Chair and Planning Commissioners
Escondido Planning Commission
Via email

RE: Agenda item #2: Direct re-design of the Alexan and Bethel Baptist Church proposal (PL-23-2073 et al) to protect to protect human health.

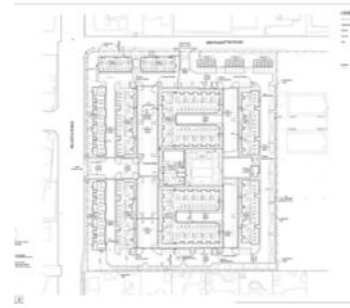
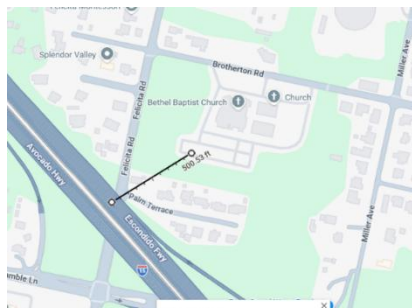
As you can see in the maps below, a re-design that would result in protecting public health through separation from the freeway does not impact a large portion of the site and could be accommodated.

Please direct the developer to relocate the housing units from the Southwest corner of this project to remove residents for 500-foot buffer area.

This is a [map from the FEIR](#) (p.268) showing the increased Residential Cancer Risk areas from High Volume Roadways.² Yellow and light green show extent of elevated cancer risks.

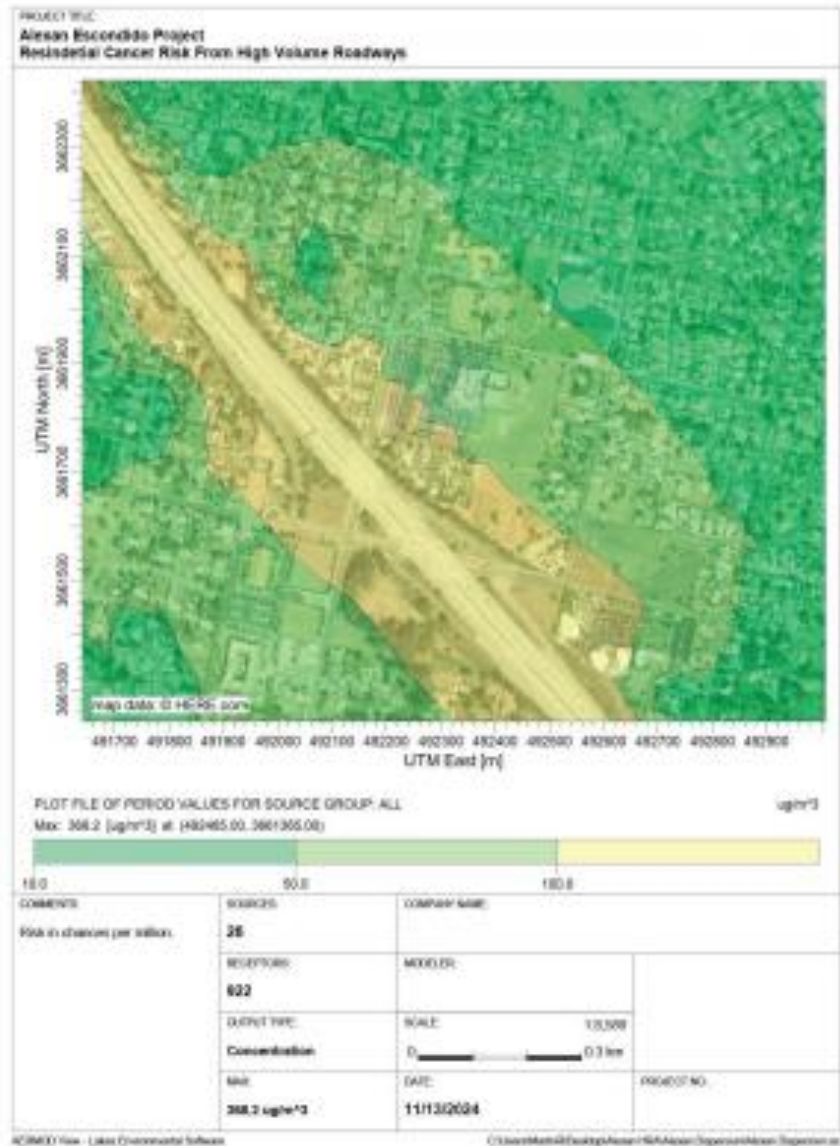
Anticipating a justification often made for building in this unhealthy zone (that there are already homes within 500 feet of the freeway), we suggest the city's appropriate and best planning response is to **prevent expansion of this negative impact** on public health in the city.
